ADDENDUM # 1

BID NO. : 2323
OPENING: 3/21/13 - 3:00 PM
COMMODITY: Coddington/Hopkins Bathroom & Door Replacement

ADDENDUM NO. 1 – March 4, 2013

This Addendum forms part of the Contract Documents and modifies the Bidding Documents dated December 20, 2012, with amendments and additions noted below, for Roger Williams Complex Bathroom and Door and Signage Replacement – Coddington and Hopkins Halls, University of Rhode Island, Kingston Campus, Kingston, RI..

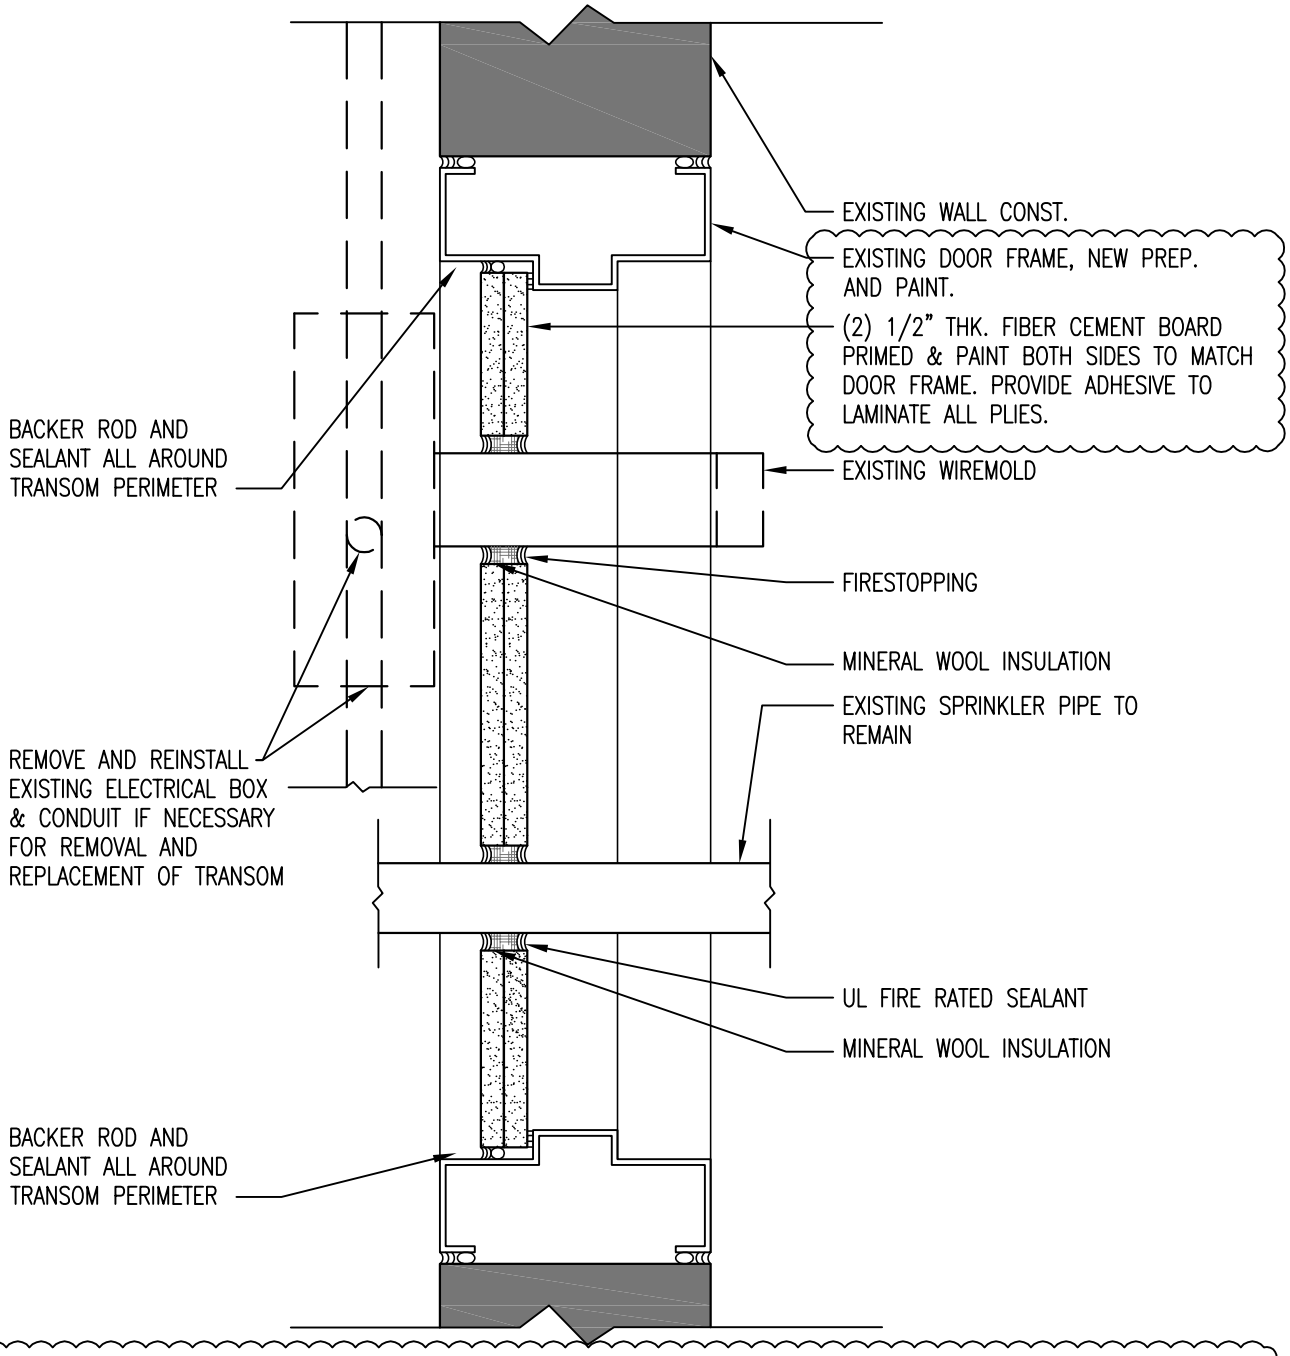
6. A8.101(Hopkins Hall), A8.102 (Coddington Hall)
Replace "Transom Horizontal Section" with attached SKA-1. Replace "Transom Vertical Section" with attached SKA-2.

UNIVERISTY OF RHODE ISLAND – ROGER WILLIAMS COMPLEX BATHROOM RENOVATION & DOOR & SIGNAGE REPLACEMENT
TRANSOM HORIZONTAL SECTION, DRAWING REFERENCE:
ALDRICH HALL: DETAIL F5, DRAWING A8.101
BURNSIDE HALL: DETAIL E5, DRAWING A8.102
CODDINGTON HALL: DETAIL E5, DRAWING A8.102
DORR HALL: DETAIL E5, A8.102
ELLERY HALL: DETAIL F5, DRAWING A8.101
HOPKINS HALL: DETAIL F5, DRAWING A8.101
